SERVICE BULLETIN

APPLICABILITY: 2019-21MY Forester **NUMBER:** 10-100-21
SUBJECT: A/C Compressor- Manufacturing Procedure Change **DATE:** 01/28/21

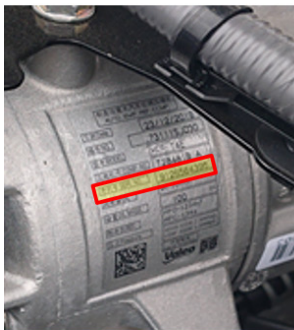
IMPORTANT: The NEW part CANNOT be identified by the Part Number. The production date code located on the compressor label must be used. In this example (**0087064586**), the “0” indicates the production year as 2020 (an “9” would be 2019, etc.). The next 2 digits, “08” indicate August as the production month (“09” would be September, etc.).

The starting date code / Serial Number for the new compressors is: **0087064586** and after.

0 = Production Year (2020)
08 = Production Month (08 = August)
7064586 = Serial Number

After confirming the customer's sound concern AND the label Serial Number is determined to be **BEFORE 0087064586**, proceed with replacing the A/C compressor assembly following the procedure in the applicable Service Manual.
